Reading Conservation Area Advisory Committee
10 April 2024

OBJECTION TO PLANNING APPLICATION 240173 – Broad Street Mall

View from the top of Southampton Street post development. From EIA Volume 2

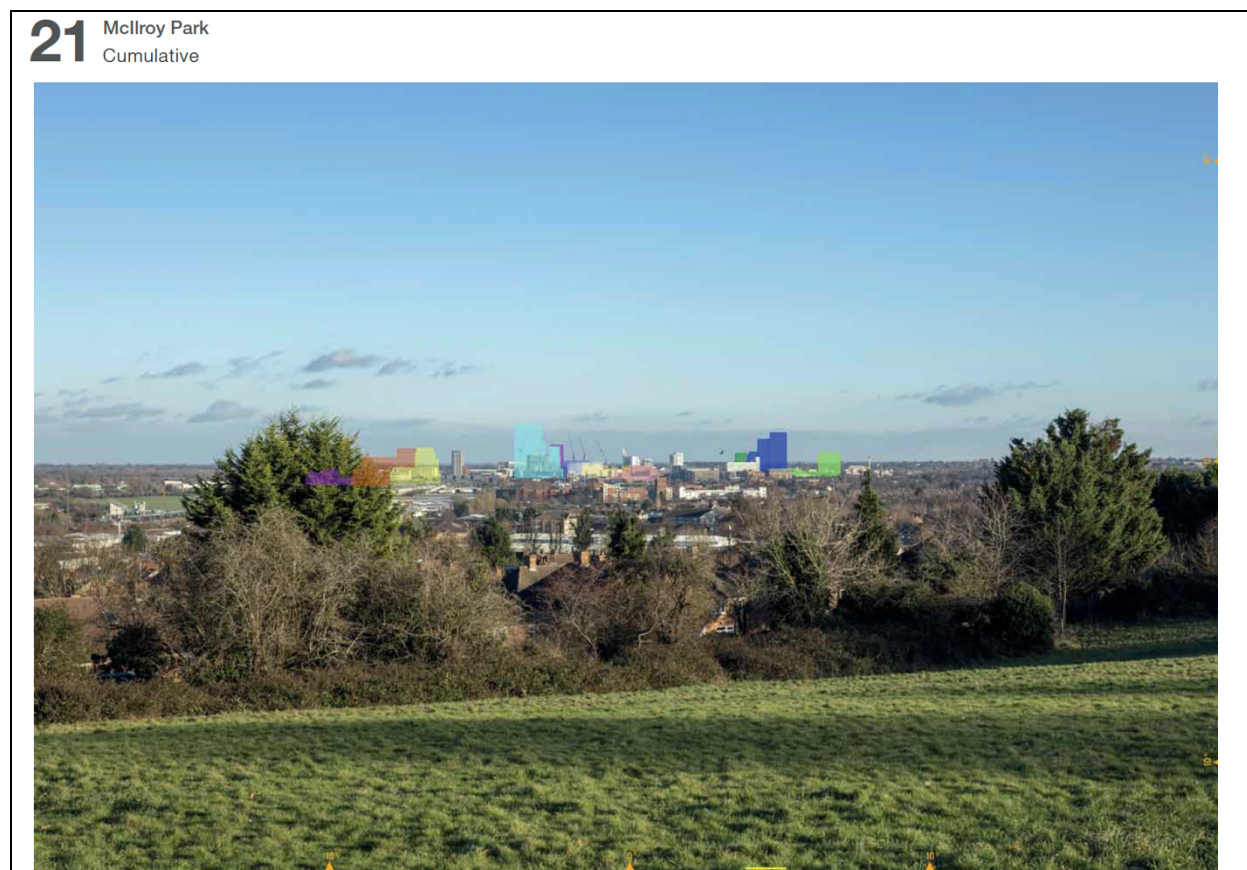
1.3.3 From the top of Southampton Street (14) and approaching St Mary's Butts, the development is the only tall building on the horizon. This does not respect the crossroads of Bridge Street, Gun Street, Castle Street and St Mary's Butts as the ancient Saxon centre of Reading; the market that the old road led to before the Abbot established his market and laid out London Street in the twelfth century.

1.3.4 The development would have a negative impact on two significant views with heritage impact as set out in Policy EN5: View 1 McIlroy park and View 2 down Southampton Street. The negative impact on both views would be less if the buildings were not as tall.
